##### 164<sup>th</sup> session

Item 4.6.1 of the provisional agenda

### **Proposal for Supplement 18 to Regulation No. 4 (Rear registration plate lamps)**

#### **Submitted by the Working Party on Lighting and Light-Signalling\***

## "Annex 3

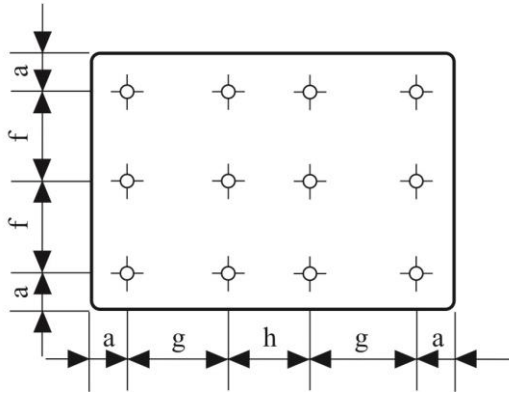
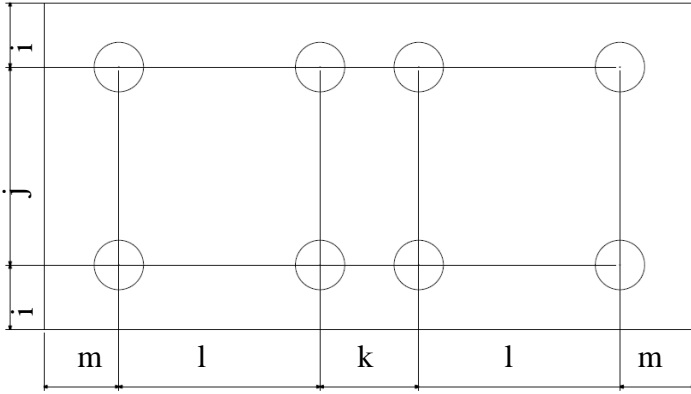
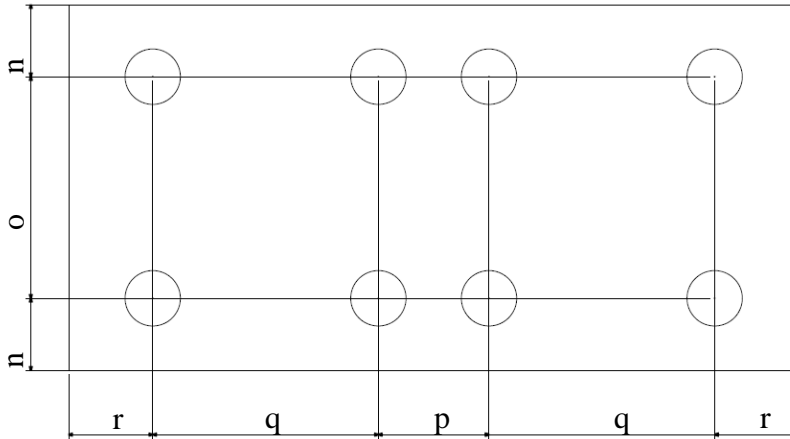
*Annex 3*, amend to read:

### Measurement points for test purposes

Category 1a (340 x 240 mm)

Category 1b (520 x 120 mm)

Category 1c (255 x 165 mm)

a = 25 mm                      b = 95 mm              c = 100 mm              d = 90 mm  
e = 70 mm                      f = 57.5 mm              g = 70 mm              h = 65 mm

Category 2a (330 x 165 mm)

i = 32.5 mm  
j = 100 mm  
k = 50 mm  
l = 100 mm  
m = 40 mm

Category 2b (440 x 220 mm)
